Explanation of Significant Differences

Upper and Lower Harbor Operable Unit

New Bedford Harbor Superfund Site

September 2001

Figure 3b

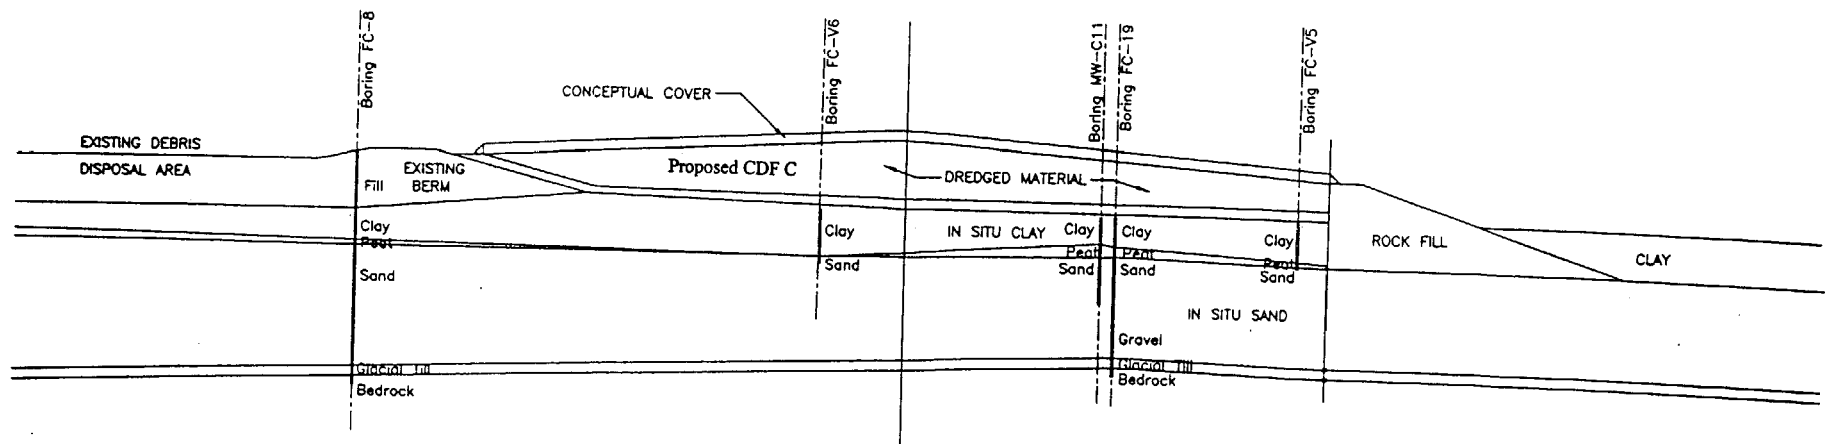
Groundwater and air monitoring have been and continue to be performed in and around the DDA, all of which indicates that PCBs are not migrating from the DDA (USEPA, 2001a, USEPA, 2001b). In addition, testing of the current surface layer of the DDA shows that it does not present an unreasonable dermal exposure risk (USACE, 2001). With regard to the soil conditions underlying the DDA, Figures 3.a and 3.b attached show the most recent cross-section

of this area, taken from the CDF C design. This cross section shows a clay layer sandwiched between the DDA and the underlying sands of the area. In addition, test pit logs from the pilot study report indicate a concrete slab approximately four to six feet below the 1987 ground level in much of the western portion of the DDA (USACE, 1990).

Given these groundwater, surface soil and air monitoring results, the subsurface features in the area and the fact that the dredged sediments in the DDA are naturally very impermeable, EPA will continue to use this DDA area as an interim TSCA facility for PCB-contaminated sediment from the site. This facility must comply with TSCA regulations governing remediation waste. CERCLA § 121. Section 761.61(c) of the TSCA regulations require that the EPA Regional Administrator make a determination that the facility does not pose an unreasonable risk to health or the environment. After reviewing the information contained in the administrative record, the Regional Administrator, by his signature on this document, determines that the facility does not pose an unreasonable risk to health or the environment as long as the following conditions are maintained: (1) Groundwater and air monitoring of this area is continued as long as the PCB contaminated sediment remains in place; (2) subsurface conditions remain intact; (3) surface PCB levels in the DDA remain low or, alternatively, a clean soil cover (approximately six inches thick) is placed so that it does not pose an unreasonable risk to health or the environment and (4) a final resolution of the facility is made in a later decision document.

ENVIRONMENTAL PROTECTION AGENCY
NEW BEDFORD HARBOR SUPERFUND SITE
NEW BEDFORD, MASSACHUSETTS
CONFINED DISPOSAL FACILITY "D"
ROCKFILL DIKE ALTERNATIVE
CONCEPTUAL SECTION

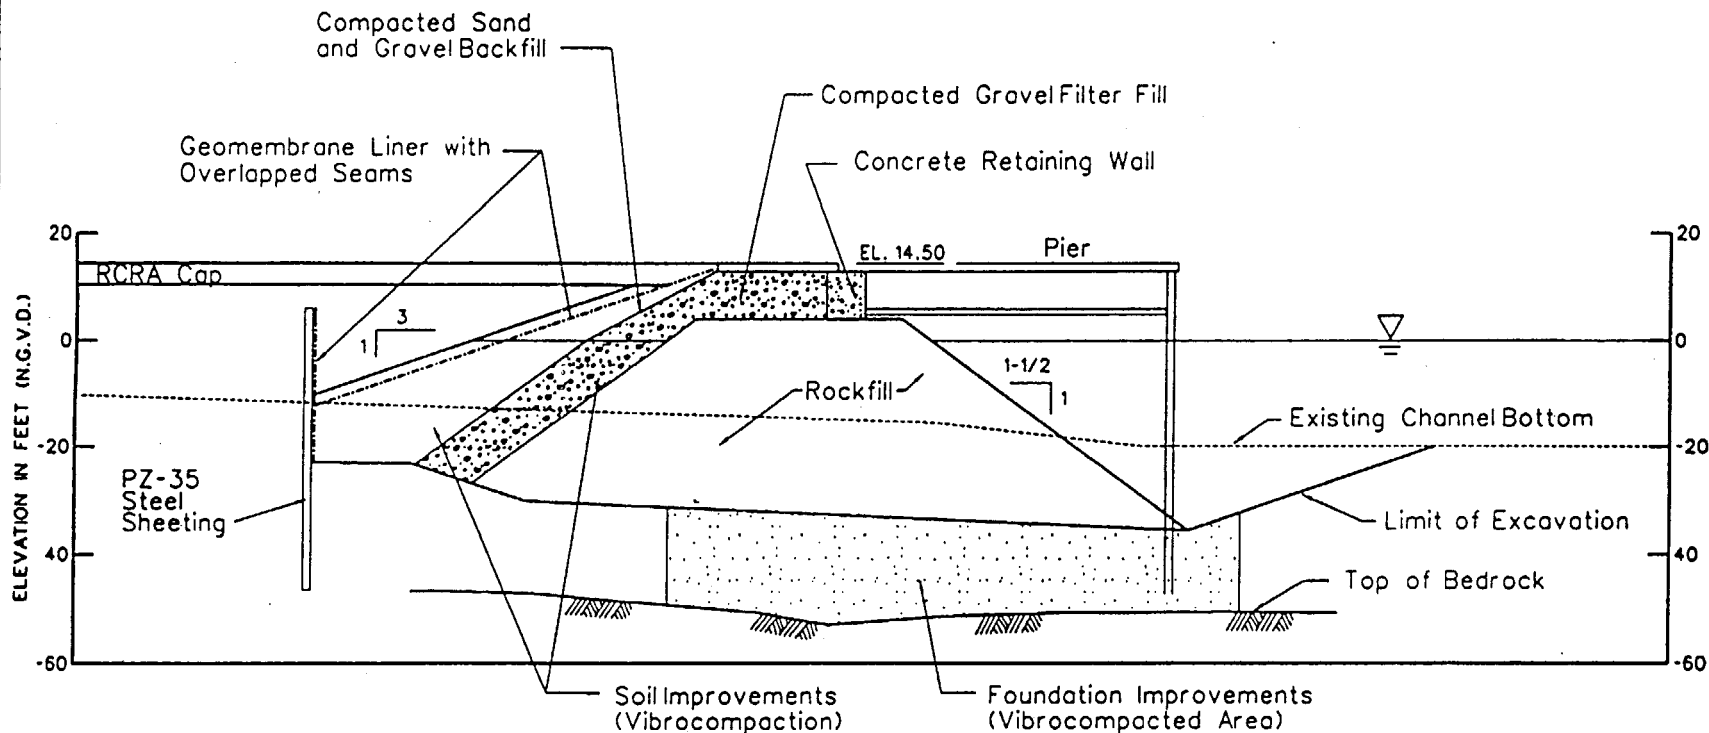
The 1998 ROD's conceptual design of the CDF D wall called for a single sheet pile wall around the entire CDF, along with a synthetic liner on the inside wall of this sheet pile to minimize PCB leakage. Sediment borings performed during the detailed design for CDF D, however, revealed the existence of very weak, silty sediments. When combined with the deep water depths in the area, this new information showed that the conceptual sheet pile wall design would not meet project design criteria.

A number of different wall and dike designs were thus evaluated to replace the original single sheet pile concept. The two considered to be most preferable and cost effective were: a) a cellular sheet pile wall consisting of interconnected 66-foot diameter sheet pile cells filled with structural fill, and b) an earthen and rock filled dike. Based on current estimates, EPA believes that the rock filled dike design, as shown in Figure 4, is the best choice of these two alternatives due to its cost-effectiveness and permanence. The rock filled design is considered more permanent since it should last in perpetuity, whereas a sheet pile-based design would eventually need significant maintenance or replacement.

It should be noted that, with either of these dike designs, due to the very soft and geotechnically weak sediments in the area, approximately 300,000 cy of these sediments would have to be removed and replaced with structural fill as the first construction step (USACE, 2000). These "foundation" sediments would not necessarily be contaminated with PCBs since they exist at deeper, cleaner depths than the contaminated surficial sediment.

Figure
5

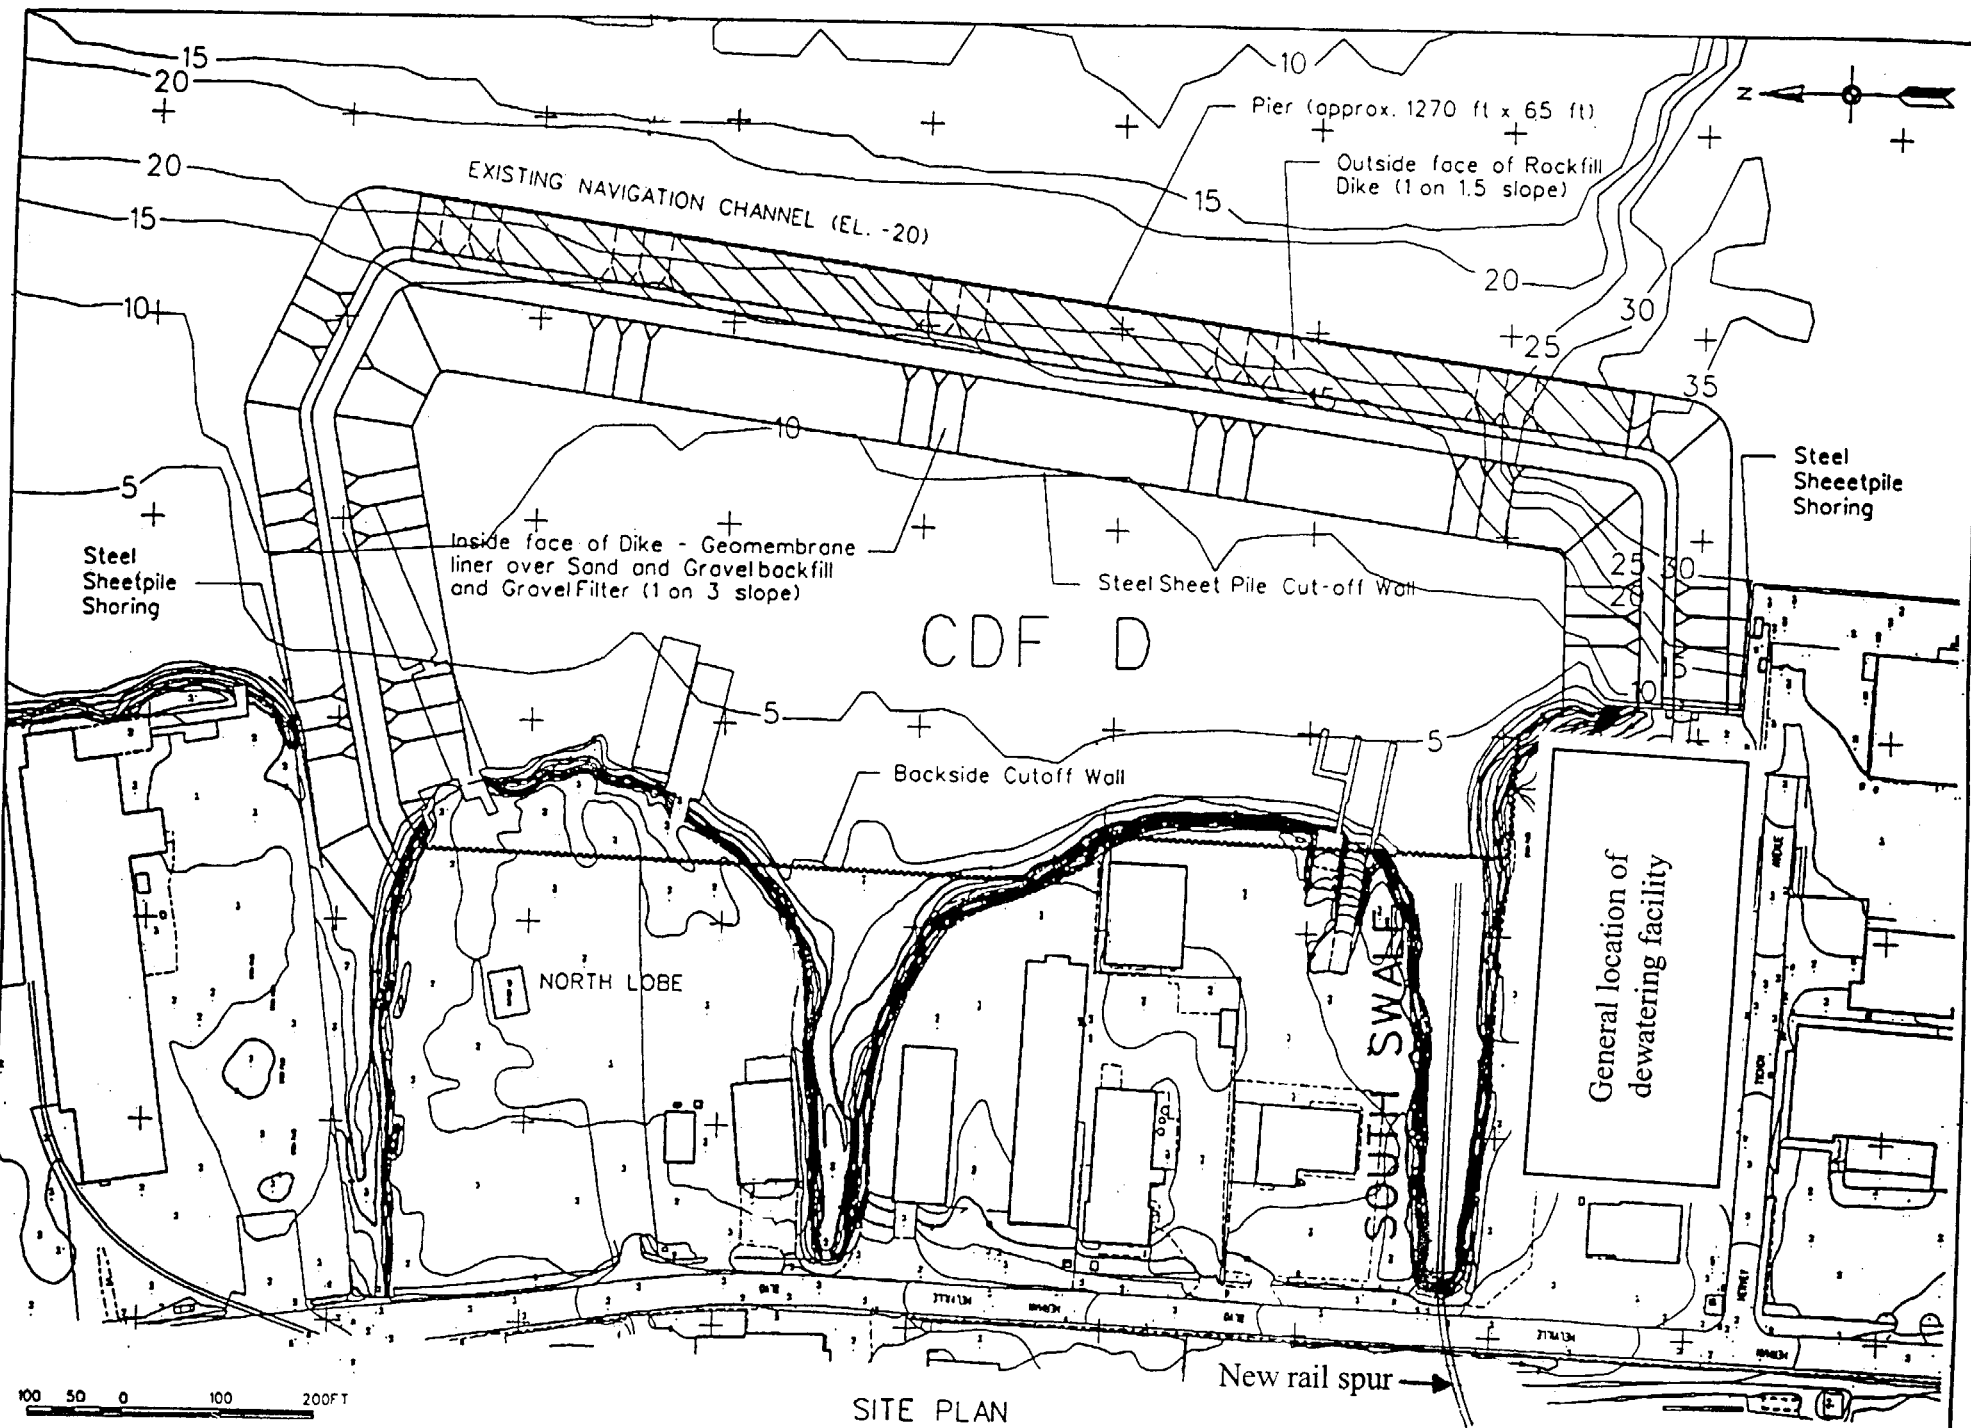
considered insignificant (see p.29 of the 1998 ROD); d) it produces a sediment "cake" which can be placed mechanically and which is dryer than the slurry from hydraulic dredging, thereby decreasing the time required for consolidation and temporary capping of sediment placed in the CDFs; and e) it allows the earlier application of heavier loads during beneficial reuse of the final CDFs. The conceptual location of the dewatering facility is shown in Figure 5 attached.

In addition, due to the inclusion of mechanical dewatering discussed above and the volume reductions it allows, the overall footprint of CDF D has been reduced from that conceived in the 1998 ROD. Figure 5 attached shows the revised footprint with the rock filled dike design. This reduction has eliminated the need to relocate the navigational channel in this area, which would have been covered by the original CDF D footprint.

As discussed in Section II.D, the current CDF wall design requires substantially more construction material than the ROD's conceptual sheet pile wall design, and the 300,000 cy of "foundation" sediments would likely need to be transported offsite. Use of rail for this material delivery and offsite transport would thus help alleviate community concerns about increased truck traffic during the remedy. Addition of a rail spur also aligns with the City of New Bedford and Harbor Development Commission's long term plans for a multi-modal port facility for the CDF D area, as developed in their recent harbor master plan (New Bedford, 2001; VHB, 2000). The conceptual location of this rail spur is shown in Figure 5 attached.
